## C. 34 Blackberry Dr - Exterior Elevations - 20-788

## 34 Blackberry Dr - Exterior Elevations - 20-788

## A. 34 Blackberry Dr - Exterior Elevations - 20-788

### Front Elevation Alterations:

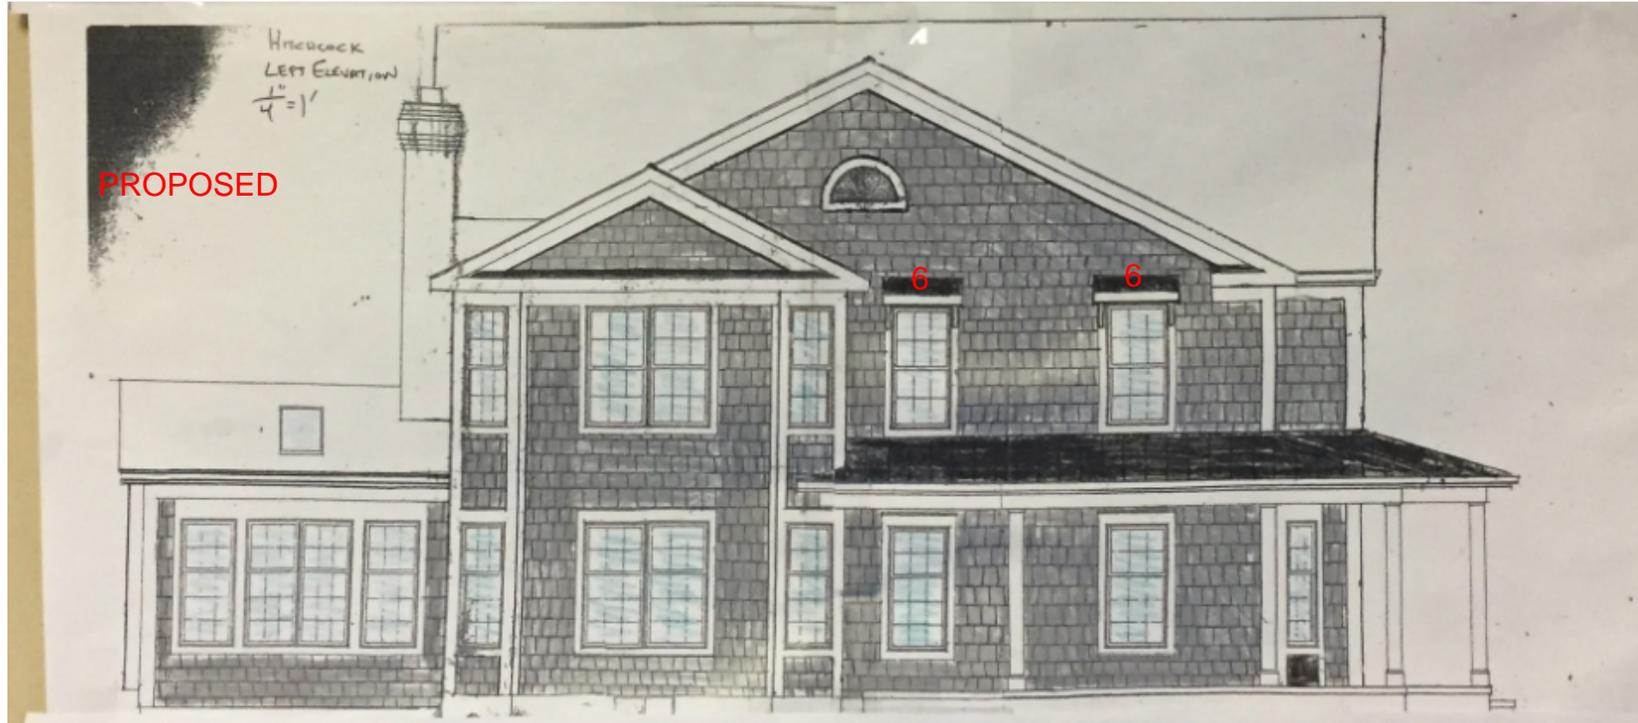
1. Gable over 6' wide window on left of house to match/balance gable on dormer over garage
2. Remove Shingled "shelf" over (3) windows in main front gable and provide short returns on each side of gable (to allow monolithic look of shake)
3. Add small window in attic area of gable
4. Add 4 small awnings with same standing seam metal roof as porch over 3 exist windows and the 1 new window in Gable

Rear Elevation Alterations

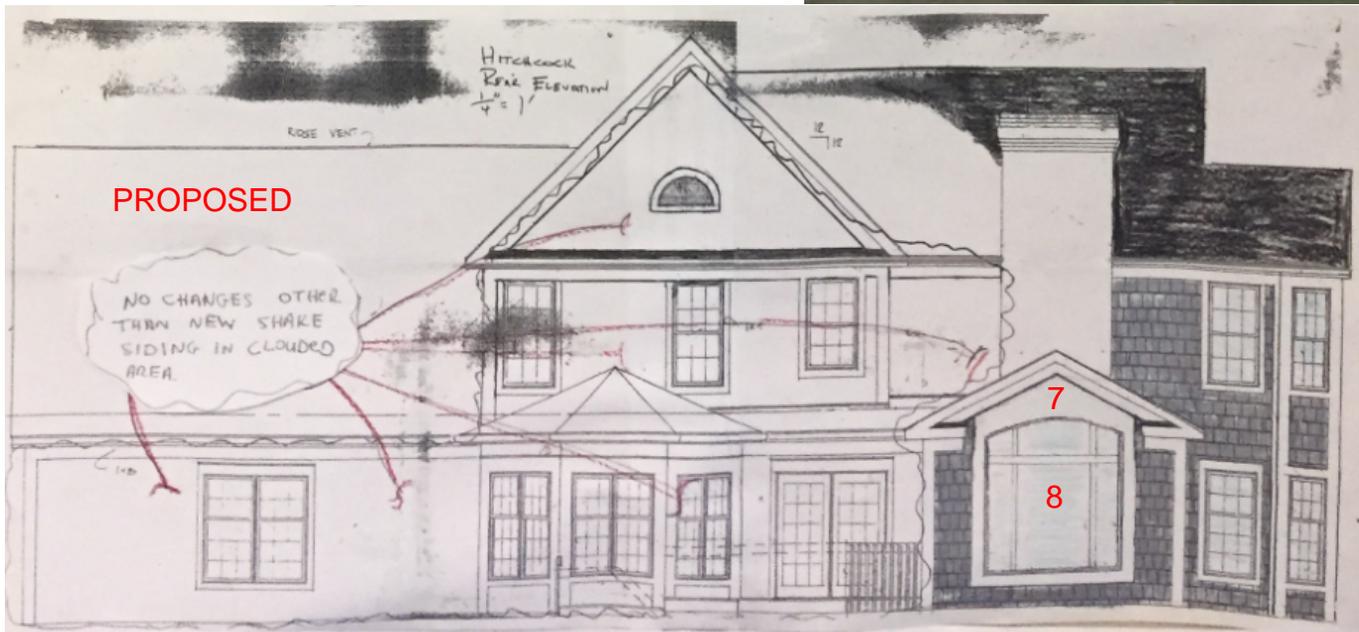
7. Remove Shingled "shelf" over (3) side by side windows in vaulted sunroom and provide short returns on each side of gable to allow height for palladium window.

8. New window with palladium added in sun room as shown
